**HIROSE ELECTRIC CO., LTD.**

## Notice of Change to the Spring Material for micro SD Card Connector (DM3BT Series)

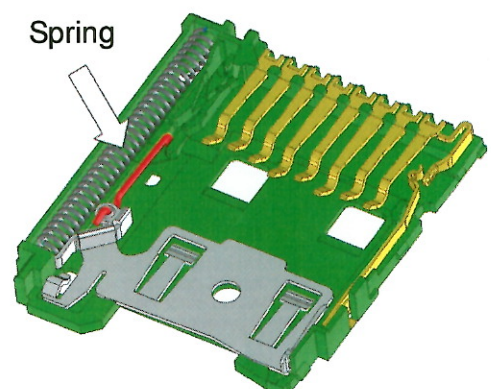
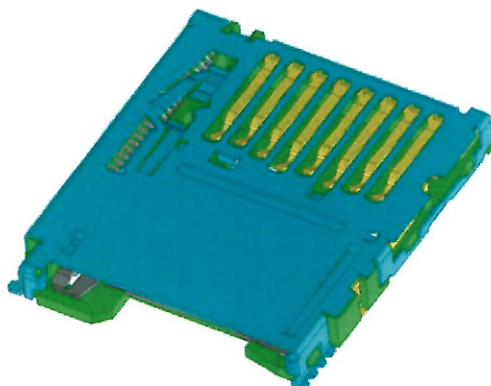
Hirose Electric will be changing the spring material used in the DM3BT connectors.

The change will be incorporated to improve resistance to corrosion.

Material of Spring	
Before the Change	After the Change
SWPB+Ni Post Plating	SUS301 No Post Processing

Changes are scheduled to be implemented for production lots as of March, 2011.
